CLARIFICATION # 3
FOR
PROCUREMENT OF PLANT DESIGN, SUPPLY, DELIVERY, INSTALLATION, TESTING
AND COMMISSIONING OF
LOT 1: LAPSIPHEDI-RATMATE-NEW HETAUDA 400kV D/C TRANSMISSION LINE
LOT 2: RATMATE-NEW DAMAULI 400kV D/C TRANSMISSION LINE
LOT 3: NEW DAMAULI-NEW BUTWAL 400kV D/C TRANSMISSION LINE (BASE)
AND NEW BUTWAL -NEPAL/INDIA BORDER 400kV D/C TRANSMISSION LINE
(OPTION)

Ref No: MCA-N/ETP/CB/003

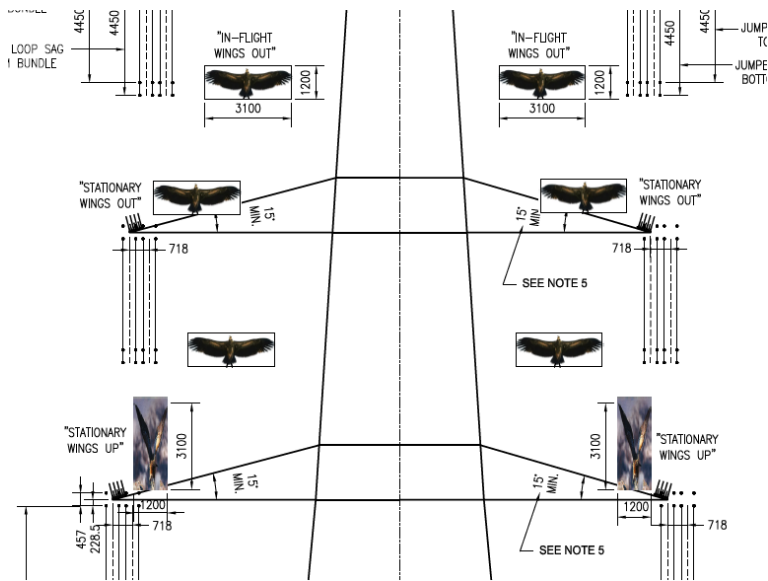
tower locations from those presented in these requirements and the tower foundation has to be accommodated within the perimeter of the land acquired by the Employer.”

As per the above clause, we understand that bidder has to accommodate the foundation back to back within the land acquired by the employer.

Please provide any foundation back to back width restriction to be followed to accommodate foundation back to back within the land acquired by the employer.
